**BULLETIN  
TO  
DESIGN AND CONSTRUCTION PROFESSIONALS**

**Date:** July 1, 2017  
**Bulletin:** 0004 – 2017  
**Section:** 28 13 00 – Access Control System  
**Re:** APS Design Guidelines and Standard Specifications Update

**Access Control Specifications**

May 8, 2017

# Door Station

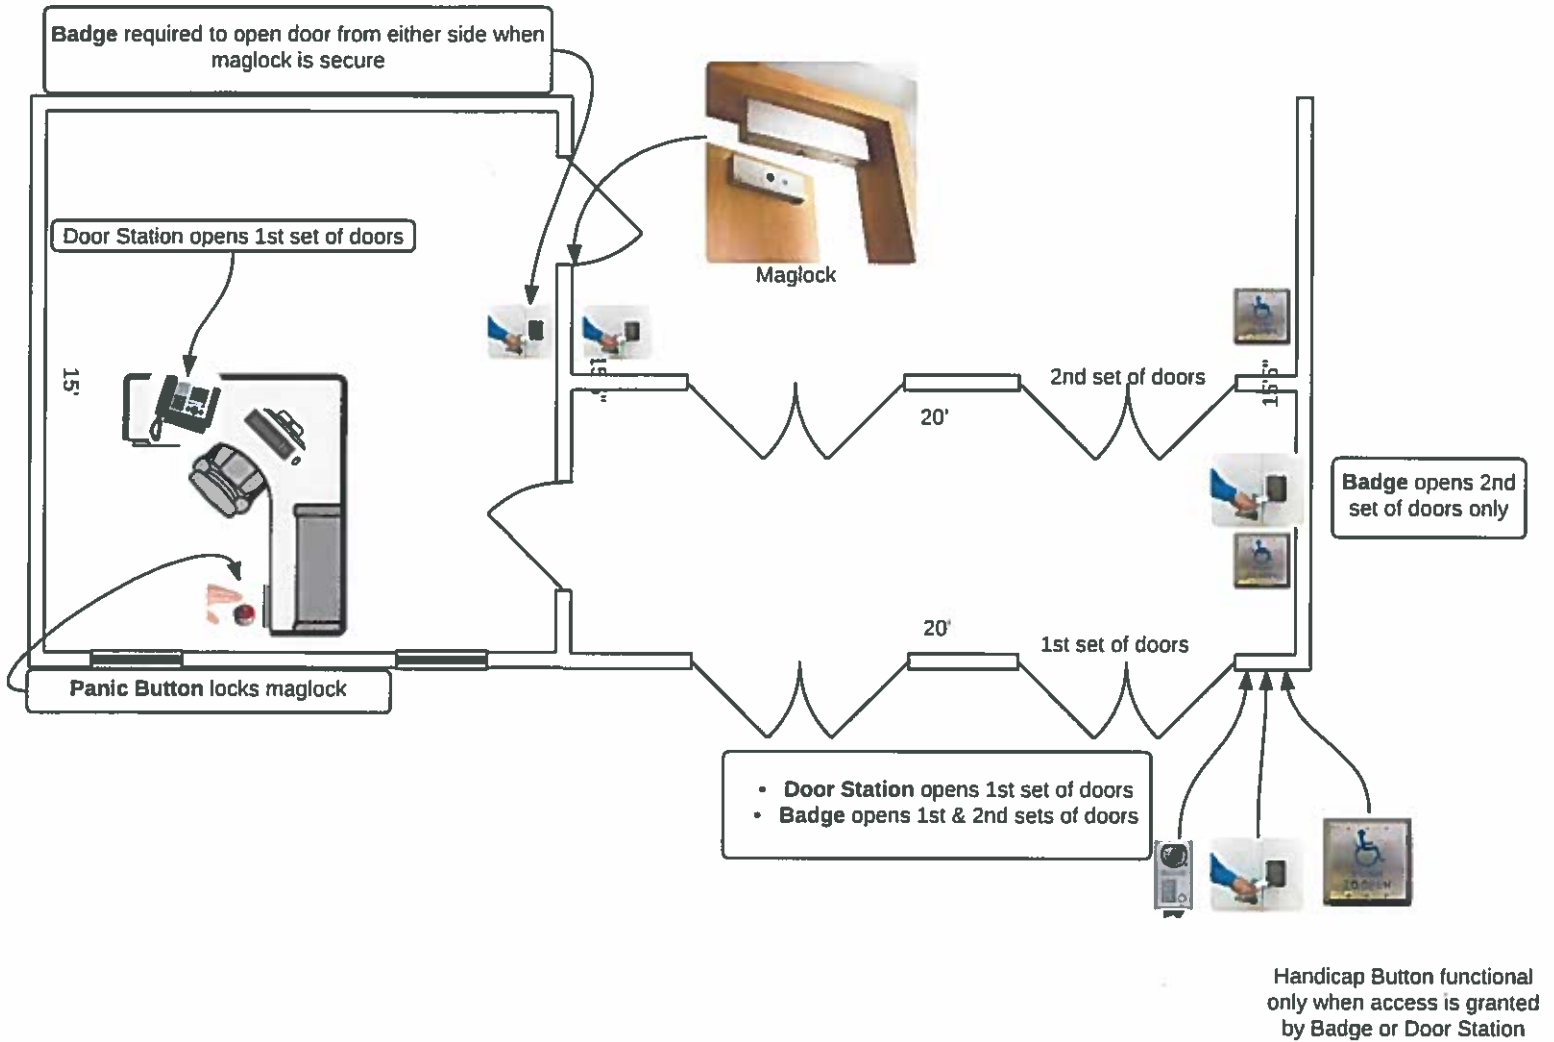
- Remove Aiphone Door Stations and replace with Axis Communications A8105-E Network Video Door Station
- Remove Aiphone master station and replace with Cisco CP8865 Video Phone
- Remove Freezer/ Cooler monitoring probes

3.15 Axis Door Station - The Axis A8105-E consists of a door station with an addressable IP video camera. A call from the door station is received at the Cisco CP-8865-K9 where the monitor has video and audio communication with the door station to verify the identity of the caller. The monitor pushes a door release button on the Cisco phone that connects to the ACP causing the electric strike at the entry door to be activated.
